RE: WATER SYSTEM IMPROVEMENTS PROJECT NO. E08-237  
CITY OF LAWRENCEVILLE, GEORGIA  
CONTRACT 2 - LAWRENCEVILLE WATER TREATMENT AND WATER DEPARTMENT FACILITIES

FROM: PRECISION PLANNING, INC. TO: PROSPECTIVE BIDDERS  
(770) 338-8000

THIS ADDENDUM FORMS A PART OF THE CONTRACT DOCUMENTS AND CONSTRUCTION DRAWINGS AND MODIFIES THE ORIGINAL BIDDING DOCUMENTS FOR THE REFERENCED PROJECT DATED FEBRUARY 2010.

ADDENDUM # 2  
ATTACHMENT #1

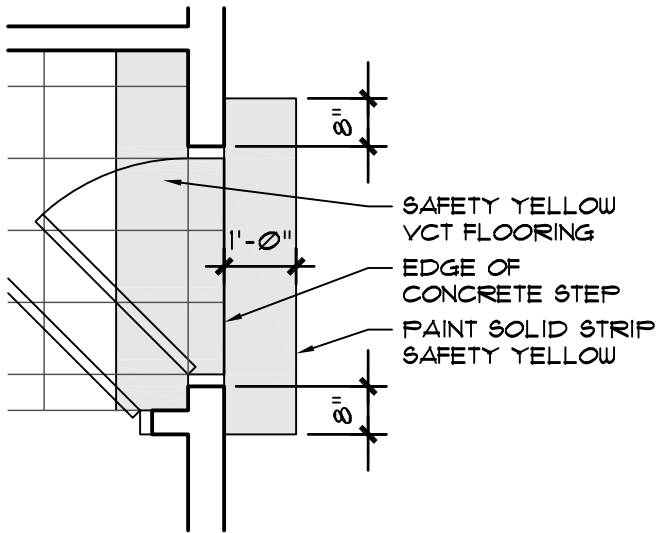
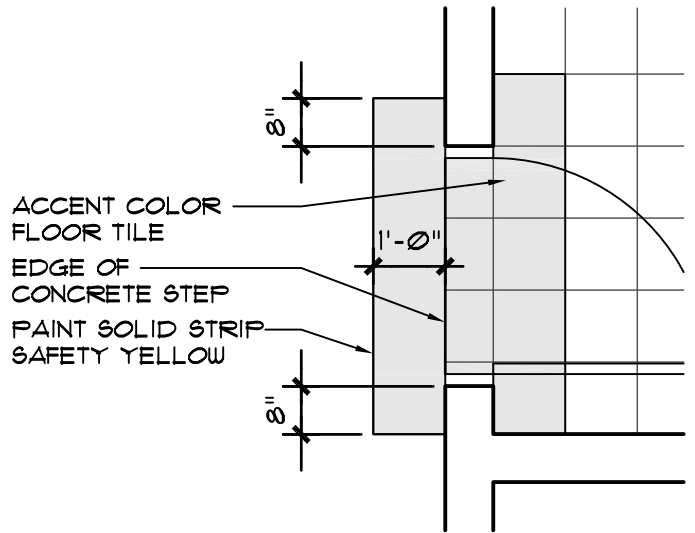
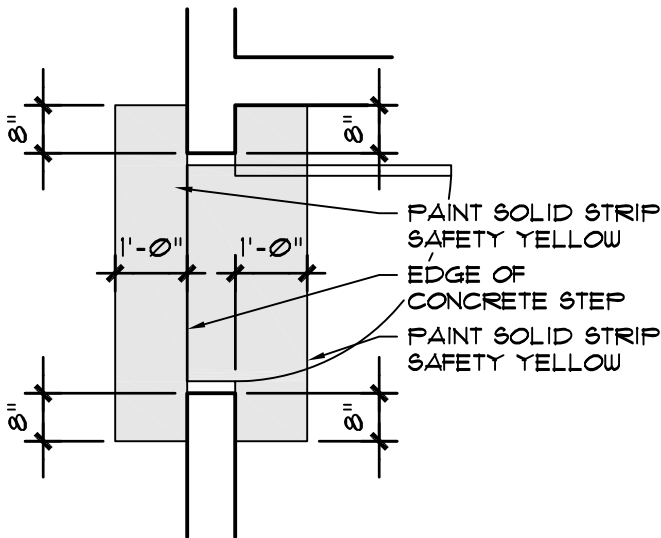
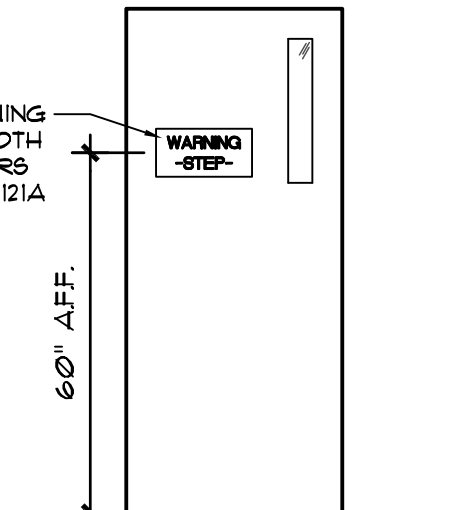
(2) **Signage Details:** Sheet A9.1. Revise Finish Plans and Schedules to include the signage details and notes as indicated on Attachment 1.

PROVIDE WARNING  
SIGNAGE ON BOTH  
SIDES OF DOORS  
#106, #117A AND 121A

1. CHARACTERS SHALL BE 2" MINIMUM IN HEIGHT.
2. THE CHARACTERS AND BACKGROUND OF SIGNS SHALL BE EGGSHELL, MATTE, OR OTHER NON-GLARE FINISH.
3. CHARACTERS AND SYMBOLS SHALL CONTRAST WITH THEIR BACKGROUND - EITHER LIGHT CHARACTERS ON DARK BACKGROUND OR DARK CHARACTERS ON LIGHT BACKGROUND.
4. MOUNT SIGNAGE AT 60" A.F.F. TO THE CENTERLINE OF THE SIGN

**ADDENDUM # 2  
 ATTACHMENT #2**

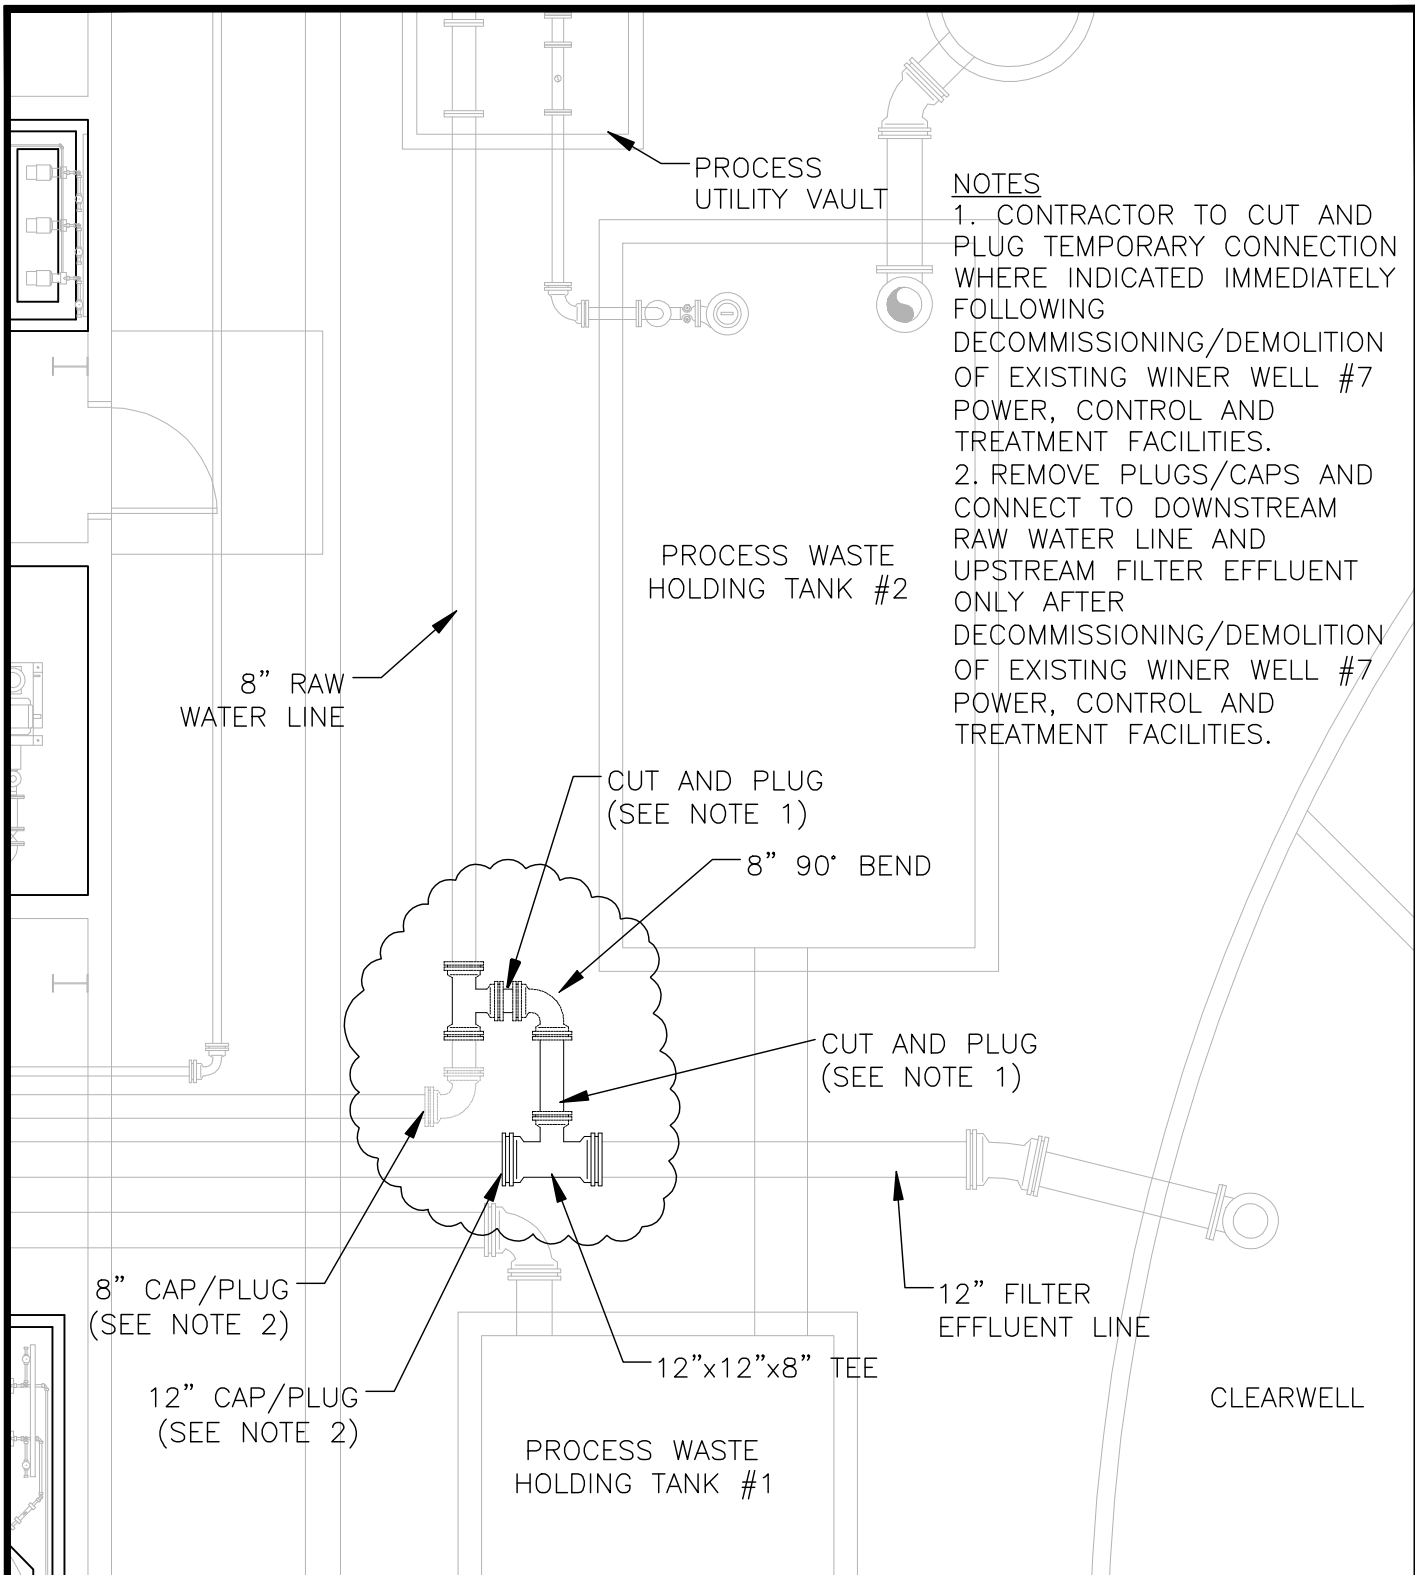
- c. Contractor shall install temporary connection between 8" raw water line and 12" filter effluent line as shown on Attachment 2. Megalugs only shall be provided for thrust restraint for 8" and 12"x8" tees and 8" 90 degree bend on temporary connection and 12" and 8" caps/plugs on permanent lines. Contractor shall clean, disinfect and test the temporary connection piping as specified in 15050 of the Specifications. Only treated water from Winer Well #7 will be allowed to flow through this connection.

Upon demolition of existing Winer Well #7 treatment and electrical control and power facilities, Contractor shall decommission temporary connection between raw water line and cut and plug temporary connection as indicated on Attachment 2.

**NOTES**  
 1. CONTRACTOR TO CUT AND PLUG TEMPORARY CONNECTION WHERE INDICATED IMMEDIATELY FOLLOWING DECOMMISSIONING/DEMOLITION OF EXISTING WINER WELL #7 POWER, CONTROL AND TREATMENT FACILITIES.  
 2. REMOVE PLUGS/CAPS AND CONNECT TO DOWNSTREAM RAW WATER LINE AND UPSTREAM FILTER EFFLUENT ONLY AFTER DECOMMISSIONING/DEMOLITION OF EXISTING WINER WELL #7 POWER, CONTROL AND TREATMENT FACILITIES.
